# A Study of Issues: Concerning a Proposed Broadband Allocation within the 900 MHz Land Mobile Radio Band and Its Potential Impact on the Florida Power & Light Network

Dan Ericson  
Senior Scientist  
Harris Corporation

Figure 1, Existing and Proposed 900 MHz Band

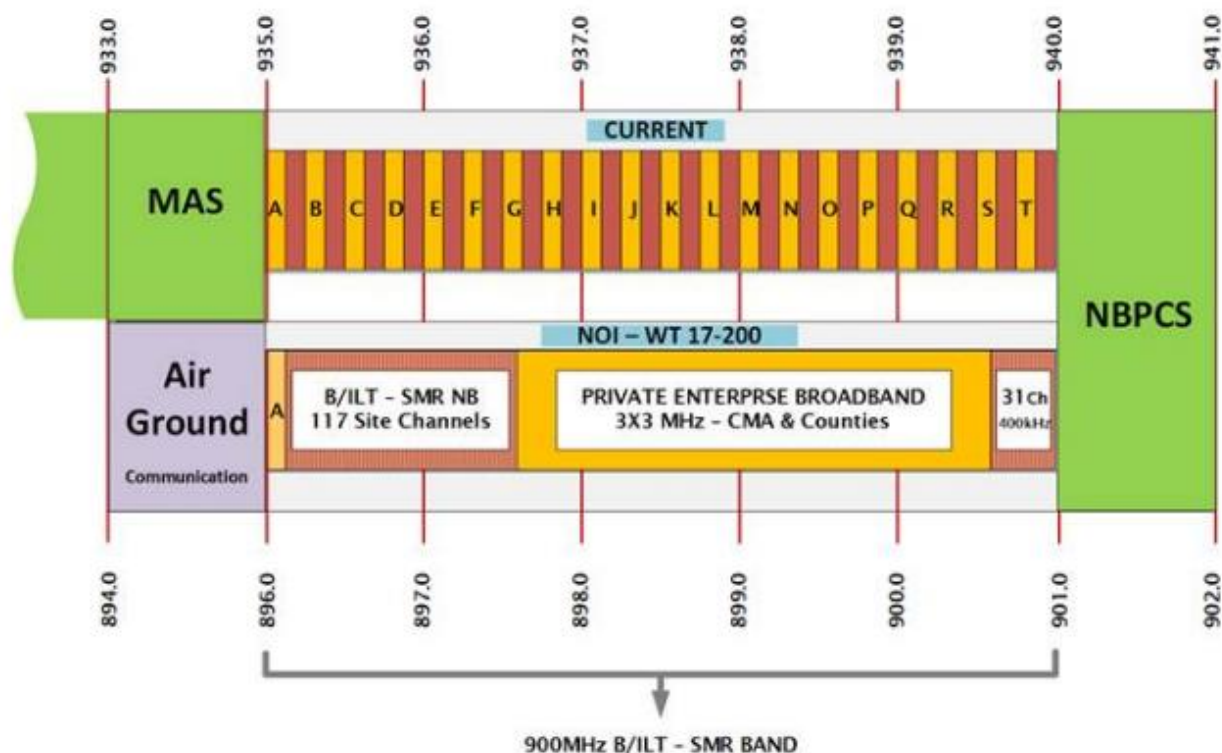
As currently proposed, the petition substantially reduces the available channels for LMR communications. Figure 1 illustrates the current and proposed frequency plan for the 900 MHz band. As shown in the current frequency plan, FPL licenses channels in the red segments (B/I/LT) of the spectrum that are interleaved with the orange lettered segments (SMR). The current rules allow for 199 frequency channels in the B/I/LT segments of which FPL has licenses for 156. The petition proposed

As proposed, the petition requires that SMR and B/I/LT licensees that currently have access to a total of 399 channels be limited to 148 channels. It further requires that licensees need to vacate any current licenses that are within the proposed broadband allocation while receiving comparable facilities within the LMR allocation. The current petition does not provide a timeframe or even a commitment for the

Figure 3, Receiver Sensitivity LOS Interference

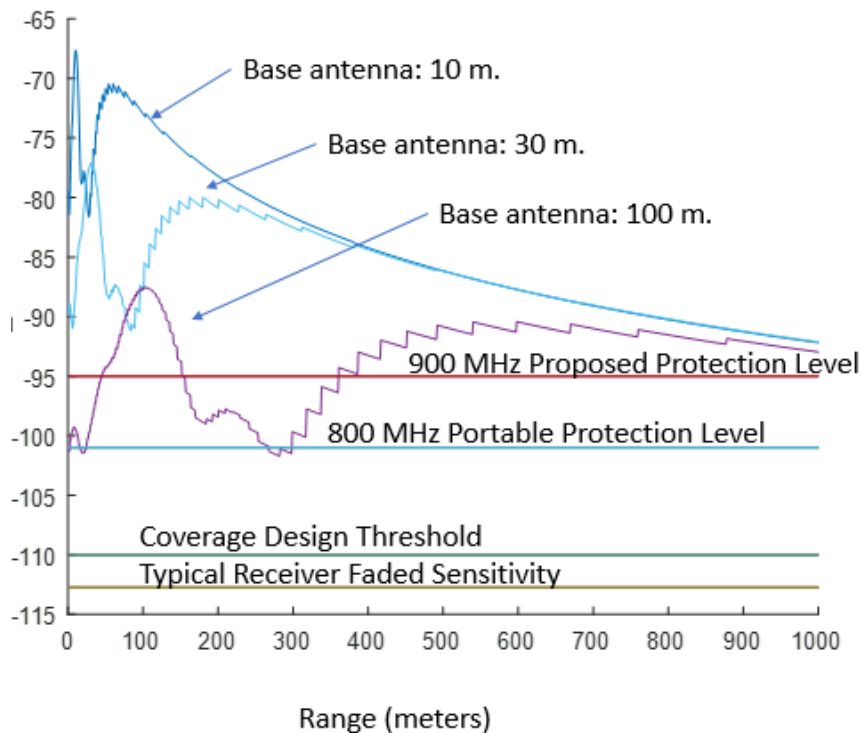
Proper interpretation of this graph is important. First, the graph illustrates the median signal strength of the desired LMR signal that must be incident at the LMR receiver for it to overcome the nearby LTE base station interference and present audio with a minimum DAQ of 3.4. Three scenarios are presented that

include PEBB base antennas at 10, 30, and 100 meters. Deployments at 30 meters are expected to be most common, but a range was simulated to demonstrate the range of interference levels that are associated with antenna height and the directivity of the base antenna. Second, the graph is based on a

Existing Commission rules also provide guidance for interference protection limitations. As previously established, the current Commission rules governing protection in the 800 and 900 MHz band based protections for the 900 MHz band on a temporary requirement to provide less protections. These levels were set as -85 dBm for portables and -88 dBm for mobiles to enable more flexible channel shuffling that facilitated the 800 MHz re-structuring. The Petitioners have already implicitly accepted that these levels are inappropriate by raising the protection levels to -95 dBm for portables and -98 dBm for mobiles. However, these levels are arbitrary and do not reflect existing precedent already provided by 800 MHz rules. Furthermore, the simulations provide by

Figure 3, Figure 4, and Figure 5 illustrate that substantially larger coverage holes around LTE sites can be expected by the proposed lesser protections. Therefore, rules that establish protection limitations at 800 MHz should be adopted for 900 MHz.

Figure 4, Receiver Sensitivity with Interference

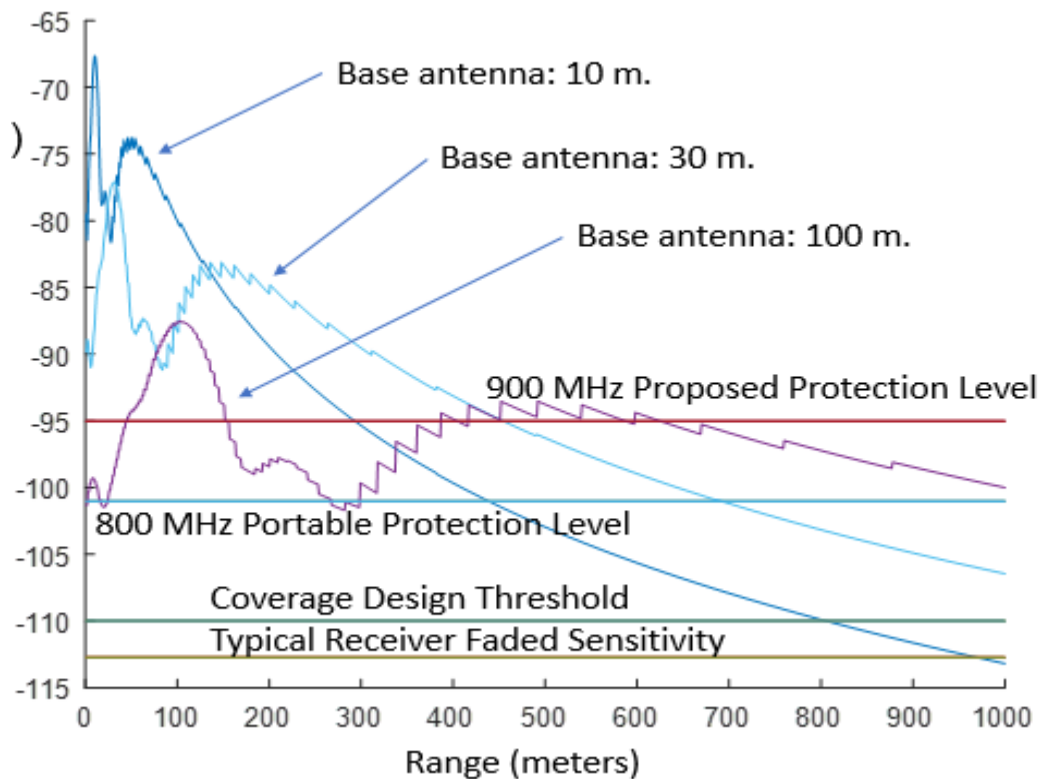
100-kHz analysis bandwidth. For the 16 LMR channels closest to the PEBB allocation, the required receiver signal may be as much as 5.3 dB higher because a 30-kHz analysis bandwidth is allowed.

The noise in the base station is treated as line of sight where free space is an appropriate model. This model would apply where the ground is relatively non-reflective, and obstructions do not exist in the field to act as barriers or reflectors. Based on this RF model, harmful interference above the protection level is continuous beyond 1 km from the broadband site.

To understand what receiver levels would be required in a more congested environment, a second model was generated that used free space losses to a range distance that was 3 times the antenna height. At greater range, a more typical coverage model using an exponential of 3.4 was used. Figure 4 illustrates that substantial interference can still be expected with a typical 30-meter cell tower

generating interference above the 900 MHz proposed protection level out to 300 meters, 450 meters with the 800 MHz protection threshold, and 800 meters before the coverage design threshold is met.

Both line of sight and more typical terrestrial models for coverage predict a substantial amount of harmful interference associated with the proposed  $50 + 10\log(P)$  emission mask. Based on this evidence of significant and harmful interference from LTE base stations, one can look to existing regulations and standards to provide guidance in similar band configurations. Specifically, do Commission rules or standards have existing rules designed to address frequency adjacency of LTE and LMR technologies?

Figure 5, Existing emission mask requirement adopted from 700 MHz

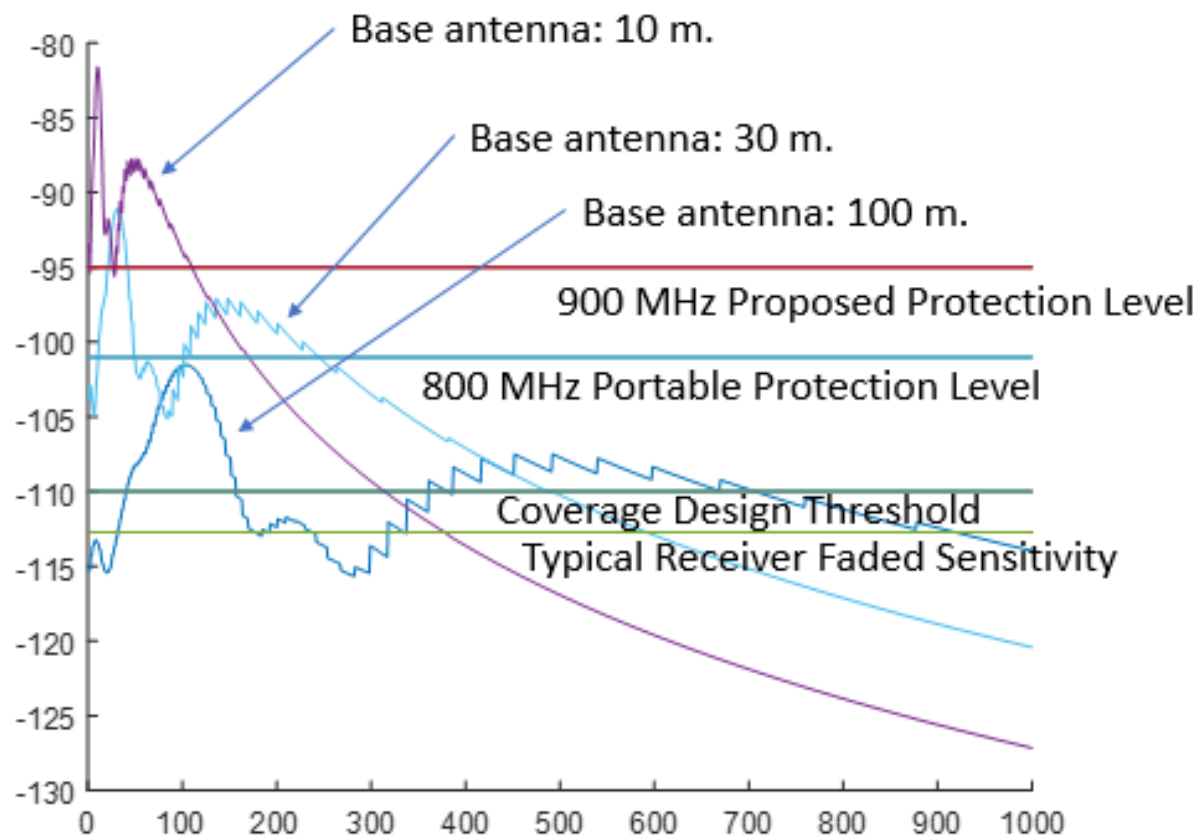
Figure 5 illustrates the simulated interference levels close to an LTE base station with the standards that have been accepted by both the FCC and 3GPP to protect the 700 MHz LMR band. With this adopted standard from the 700 MHz band, the typical 30-meter cell tower only exceeds protection threshold at much closer distances to the LTE site.

Based on the simulation results and existing rules accepted by both the FCC and 3GPP, Harris recommends that emission mask requirements for the LMR portion of the 900 MHz band should follow the same rule and require  $76 + 10\log(P)$  per 6.25 kHz. The recommended  $50 + 10\log(P)$  can be applied to other parts of the spectrum external to the 900 MHz LMR allocation.
